INFORMATION REQUEST RESPONSE
APPLICATION FOR MATERIAL CHANGE OF USE FOR MEDIUM IMPACT INDUSTRY (WATER BOTTLING FACILITY)
L10 UPPER DAINTREE ROAD, UPPER DAINTREE - LOT 10 ON SP304851

Reference is made to the Information Request issued by Council, dated 6 November 2019 and received by email on the same day.

DRAWING NO. 106-002-C01 REVISION 1

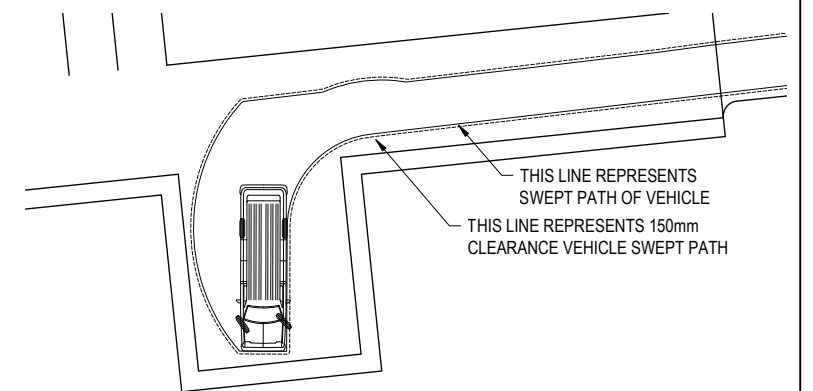
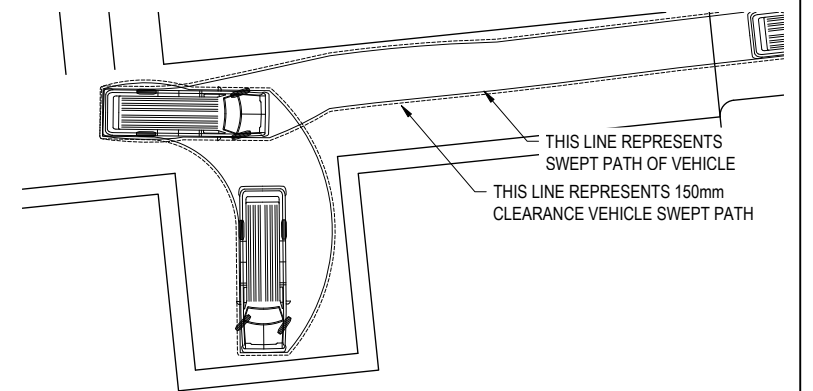
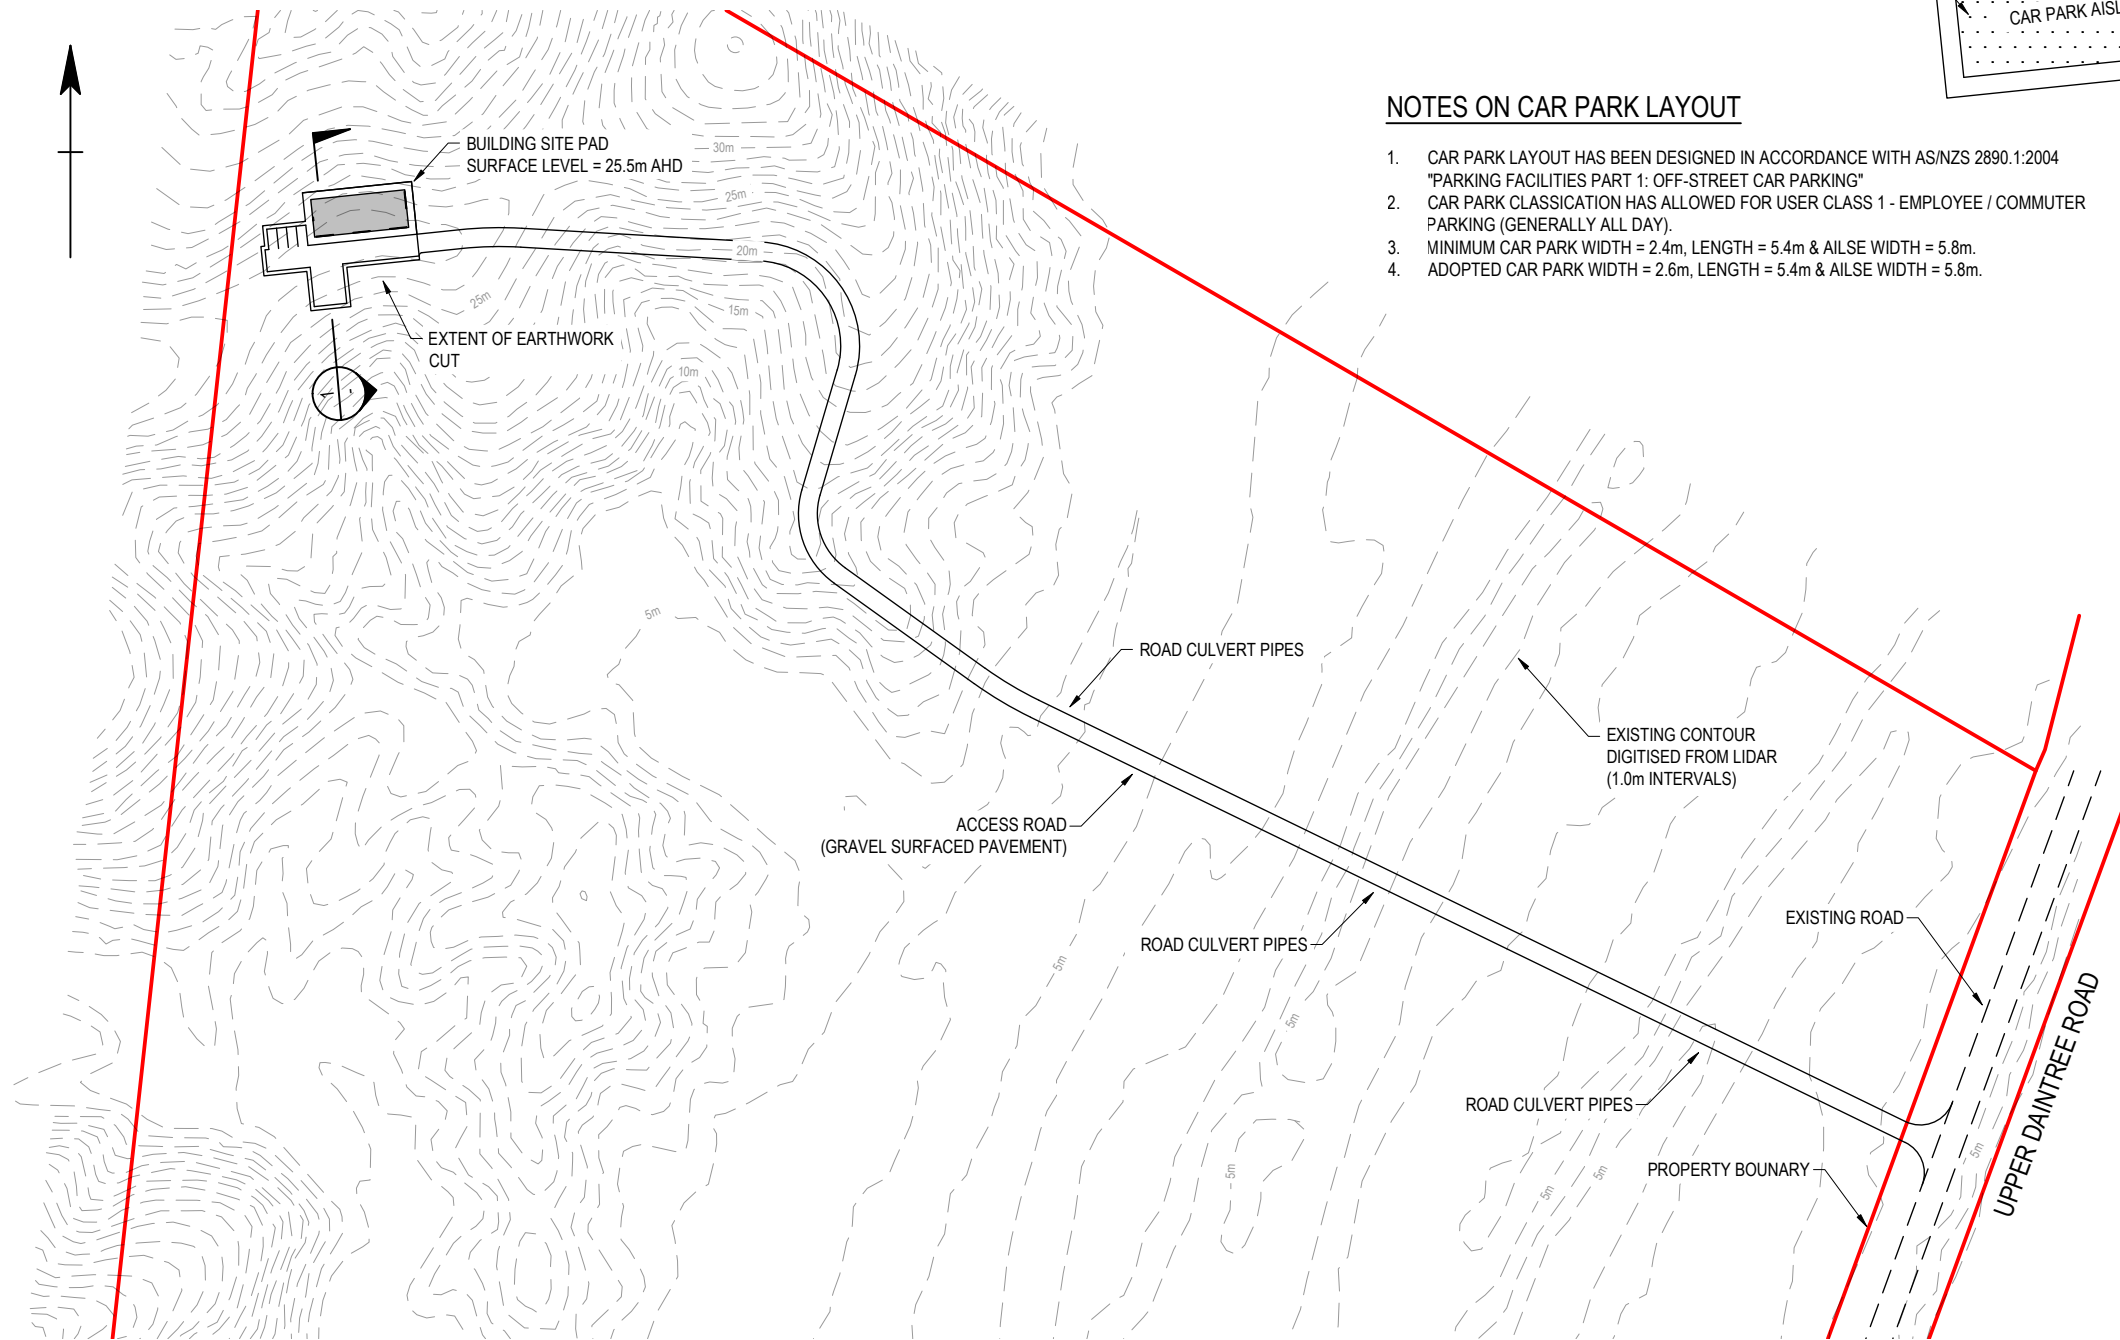
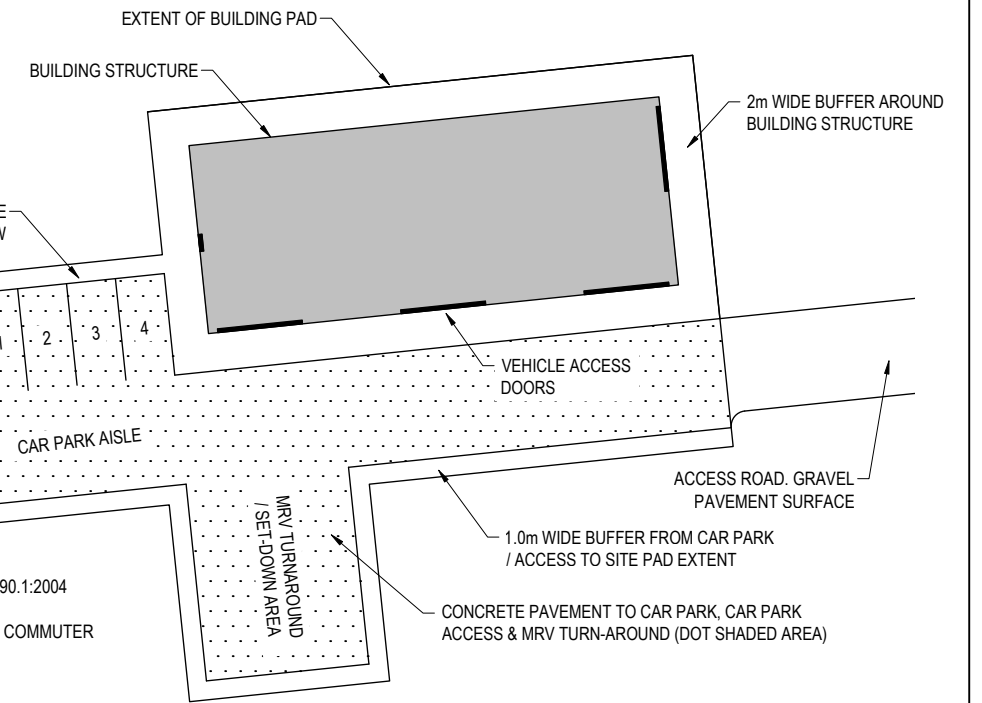
The application includes an indicative access driveway and parking area servicing the development. Provide a detailed parking layout with a set-down area for the medium rigid vehicle proposed for carting the packaged water off-site. The parking layout should include a swept path diagram for the medium rigid vehicle and include indicative plans demonstrating the extent of earthworks required to level the ridge top. Detail the surface treatment of the parking and loading area and the access driveway, any retaining structures required to level the pad and any landscaping proposed.

Enclosed at Attachment A is the Access Road & Building Pad Concept Arrangement Plan, prepared by CivilWalker Consulting Engineers (Drawing No. 106-002-C01 Rev 1). The plan shows the proposed parking layout, set-down area for a medium rigid vehicle and swept path diagrams for a medium rigid vehicle. In relation to the surface treatments, the car parking, loading and manoeuvring area is proposed to be concrete pavement and the access road will be gravel pavement.

In addition the plan shows the approximate extent of cut required for the building pad where the Water Bottling Facility building is to be located. As noted on the plan, no retaining walls or steep batters are required for the building pad.
